Subject: DA2022/0742 78 CHISHOLM AVENUE AVALON BEACH NSW 2107
WRITTEN SUBMISSION: LETTER OF OBJECTION SUBMISSION: LEITH &
WHITE

RE: DA2022/0742 78 CHISHOLM AVENUE AVALON BEACH NSW 2107
WRITTEN SUBMISSION: LETTER OF OBJECTION
SUBMISSION: LEITH & WHITE

VIEW FROM REAR OF PROPERTY

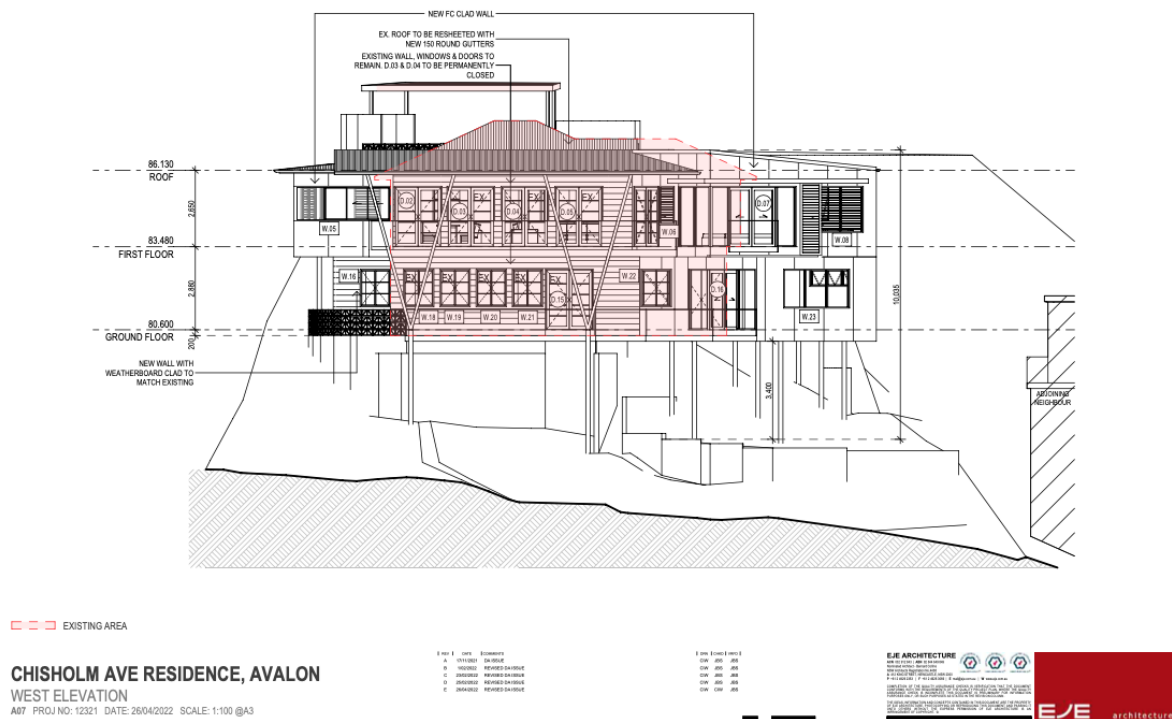
Our dwelling is to the right. We will suffer adverse amenity outcomes caused by the proposed development's substantial non-compliance to LEP and DCP envelope controls. The existing dwelling on the subject site has already 'maxed out' the envelope controls at the upper level. This proposal adds unacceptable built form to that 'maxed out' envelope, causing us severe amenity harm. Building Height 12.6m v 8.5m [48% non-compliance]; Side Setback 1.4m v 2.5m [78% non-compliance]; Building Envelope South 9.0m Height requires a 5.5m setback v 1.5m proposed [366% non-compliance] Building Envelope North 7.0m Height requires a 3.5m setback v 1.0m proposed [350% non-compliance]. The character of the proposed development does not respect the character of our dwelling – it simply will be 'swamped' by an aggressive and unsympathetic built form. The proposal is offensive, jarring and unsympathetic in the context of the immediate area.

The elevation clearly shows the existing compliant dwelling, and the proposed extensions at the upper level that are non-compliant. The relationship to our property to the right of this drawing, clearly show the unacceptable character outcomes, of a substantial 12.6m non-compliant development set against our compliant envelope.

VIEW FROM REAR OF PROPERTY

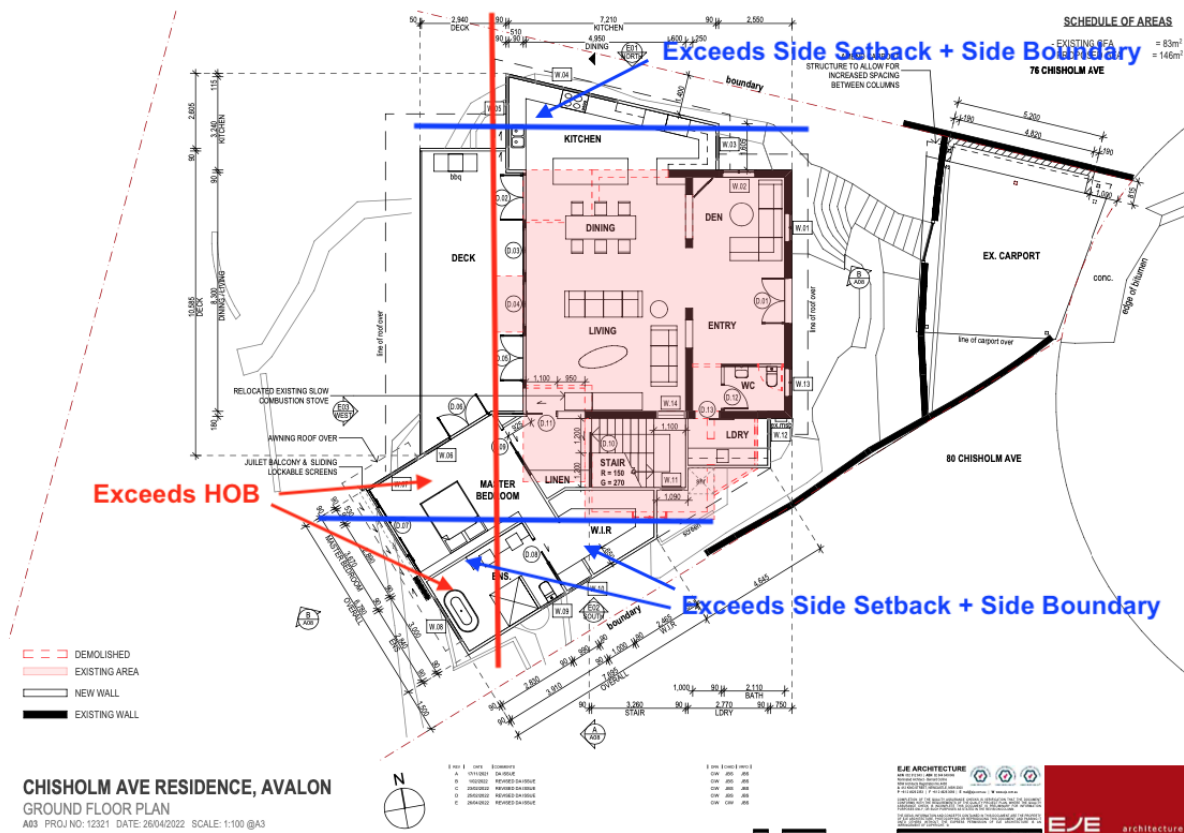
Our dwelling is in the background. We will suffer adverse amenity outcomes caused by the proposed development's substantial non-compliance to LEP and DCP envelope controls. The existing dwelling on the subject site has already 'maxed out' the envelope controls at the upper level. This proposal adds unacceptable built form to that 'maxed out' envelope, causing us severe amenity harm. Proposed Building Height 12.6m v 8.5m [48% non-compliance]

VIEW FROM SIDE OF PROPERTY

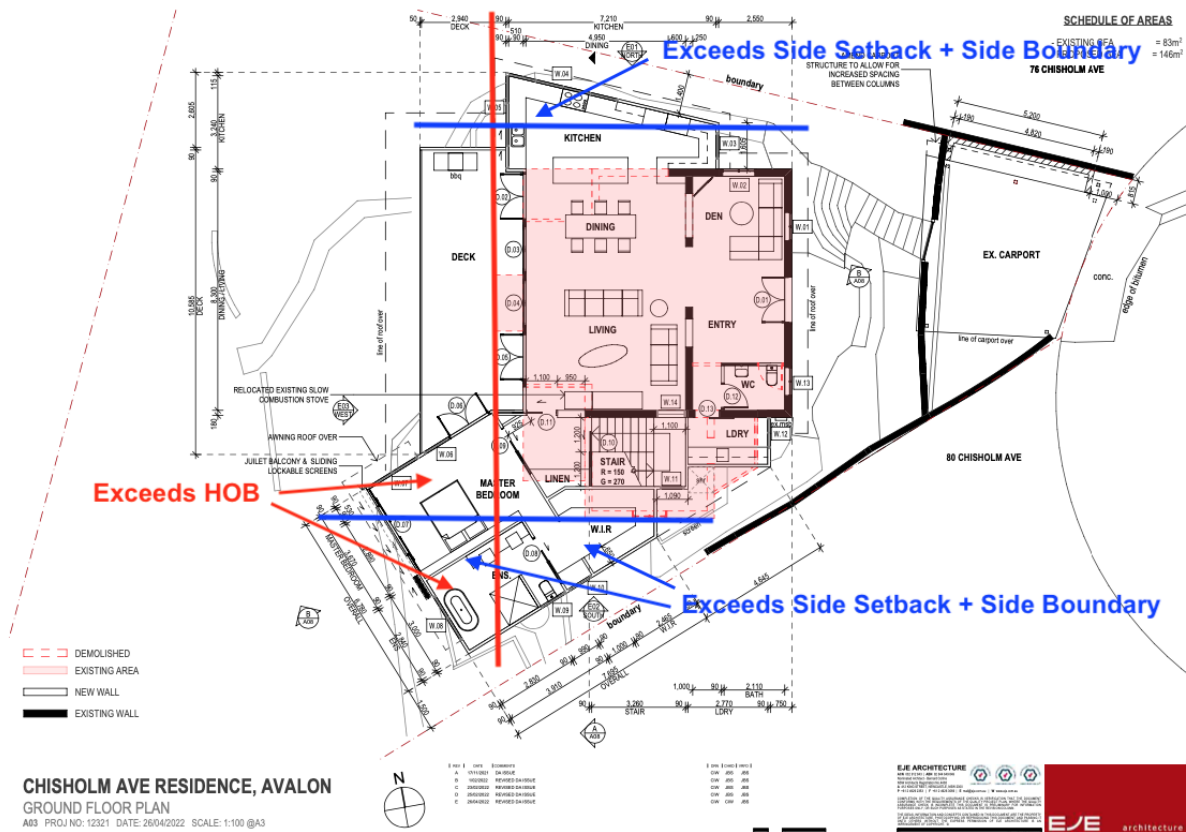
The view taken from above our property looking at the subject site. Our dwelling is in the foreground. We will suffer adverse amenity outcomes caused by the proposed development's substantial non-compliance to LEP and DCP envelope controls. The existing dwelling on the subject site has already 'maxed out' the envelope controls at the upper level. This proposal adds unacceptable built form to that 'maxed out' envelope, causing us severe amenity harm. Note that the upper floor addition does not accord with the side envelope controls, and considering the excessive heights, a compliant envelope would require a setback of 5.5m. The proposed development offers only 1.4m. This is unacceptable. Building Height 12.6m v 8.5m [48% non-compliance]; Side Setback 1.4m v 2.5m [78% non-compliance]; Building Envelope South 9.0m Height requires a 5.5m setback v 1.5m proposed [366% non-compliance]

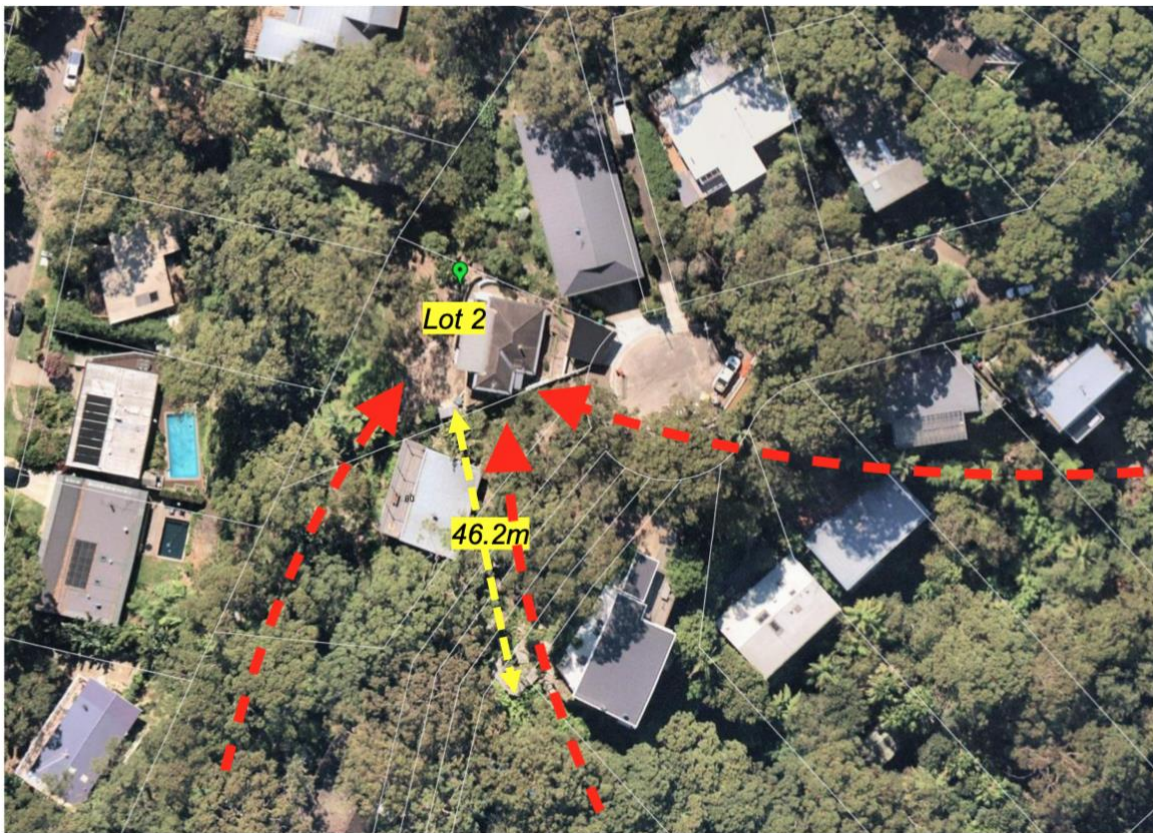
We are concerned that the Bushfire Report has under forecast the distance to the Forest canopy. The canopy from the major threat of the Cat 1 Bushfire Vegetation connects directly to the subject site, such that a bushfire firestorm coming up the steep hill, has highly inflammable material to burn right to the boundary of the subject site. We contend that the site should be BAL FZ. We ask Council to refer the matter to NSWRFs for review.

Photo 2 is a closer view of the vegetation in the area.

A bushfire firestorm coming up the steep hill, has highly inflammable material to burn right to the boundary of the subject site, delivering potential heat loads beyond the BAL 40 control. We contend that the site should be BAL FZ. We contend that there is not a 46.2m separation from the threat, as the interlocking canopy and undergrowth connects from the Cat 1 threat to the boundary of the subject site, and into canopy within the subject site

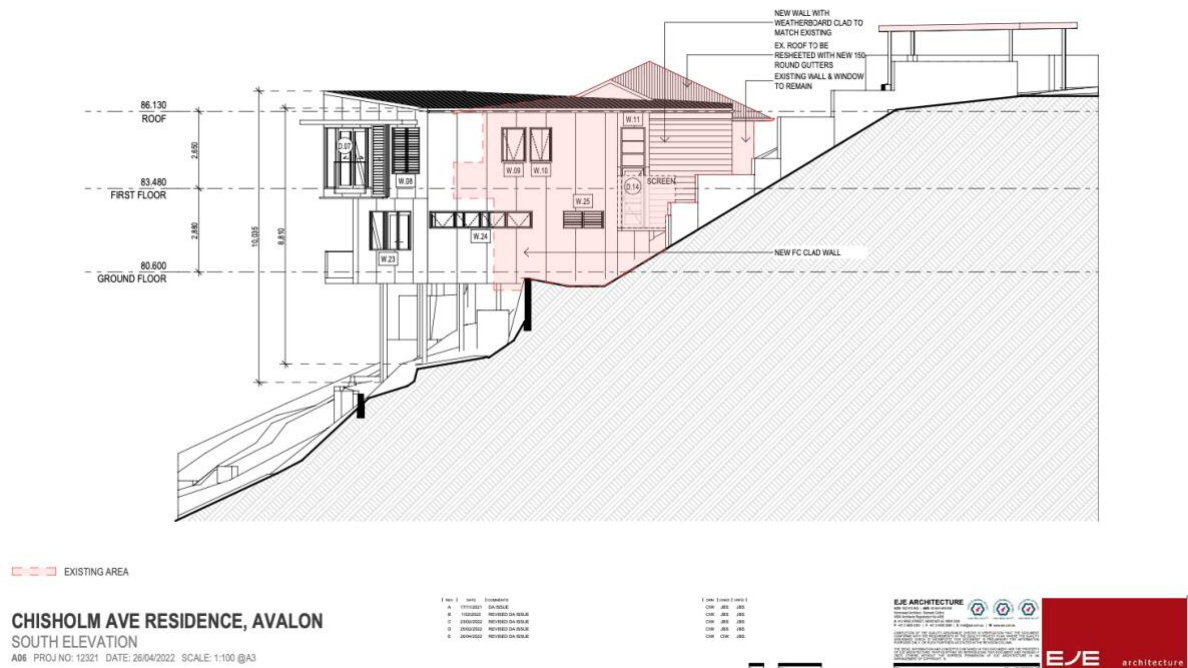
Response: The area is not undergoing change that would warrant privacy impact such as the one presented.

Comment: As the development is considered to result in an unacceptable privacy impact due to the design, it is requested that the proposed development be redesigned to reduce amenity impact on the neighbouring properties.
